END OF MECHANICAL ADDENDUM #1

DILLON CONSULTING	PROJECT CB HOUSING AUTHORITY DOMESTIC WATER UPGRADES	PROJECT NO. 212740
	DATE JANUARY 2022	TITLE 1 BEACON CR. - HOSE BIB DEMOLITION

DILLON CONSULTING	PROJECT CB HOUSING AUTHORITY DOMESTIC WATER UPGRADES	PROJECT NO. 212740
	TITLE 1 BEACON CR. - HOSE BIB RENOVATIONS	SHEET NO. MSK.MP102.1
DATE JANUARY 2022

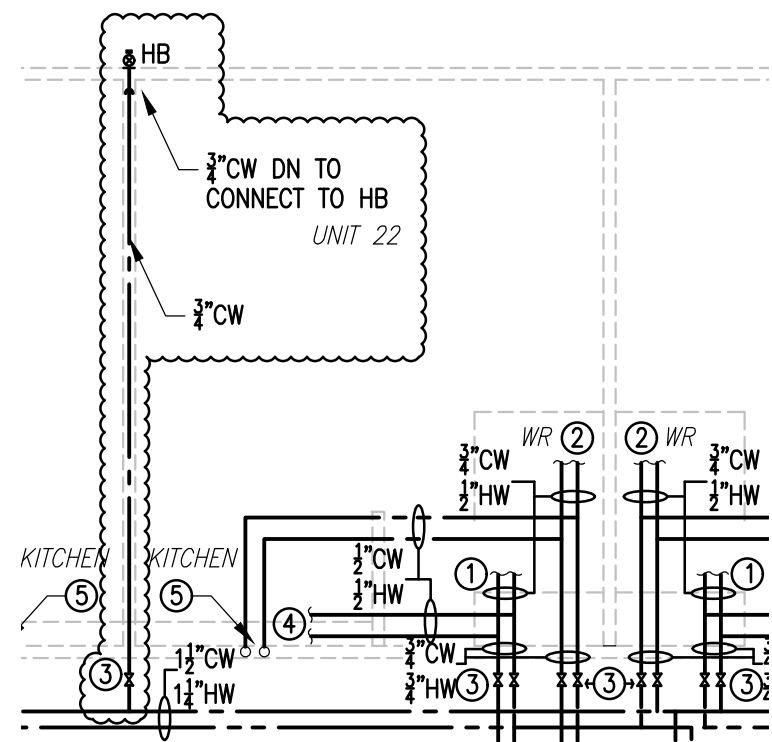
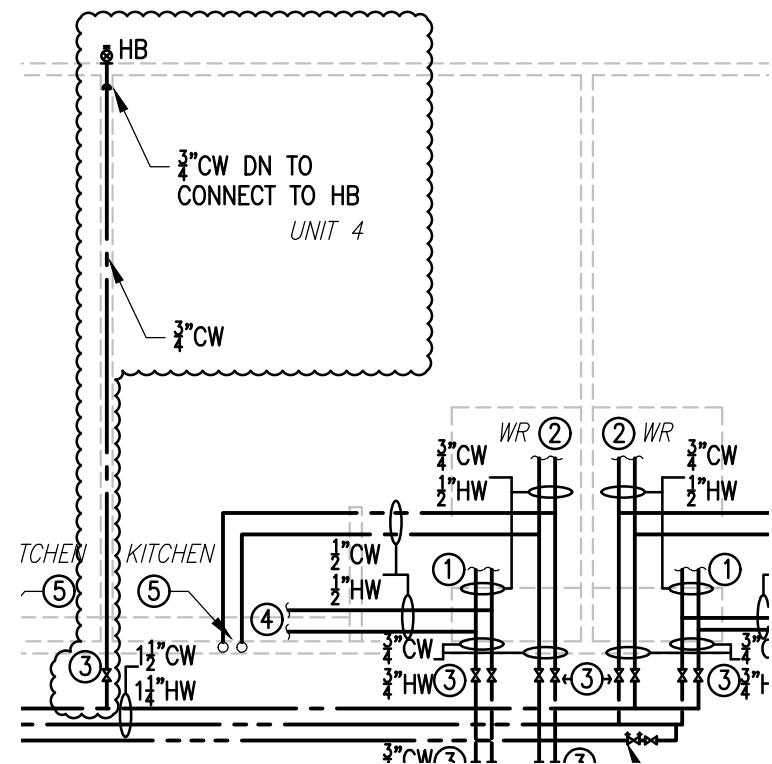
1. Existing piping, fittings, valves, etc. serving existing exterior hose bibs are to be removed as indicated on the attached demolition sketch (MSK.MP101.1).
2. New piping, fittings, valves, etc. are to be supplied and installed as indicated on the attached renovation sketch (MSK.MP102.1).

HOSE BIBS
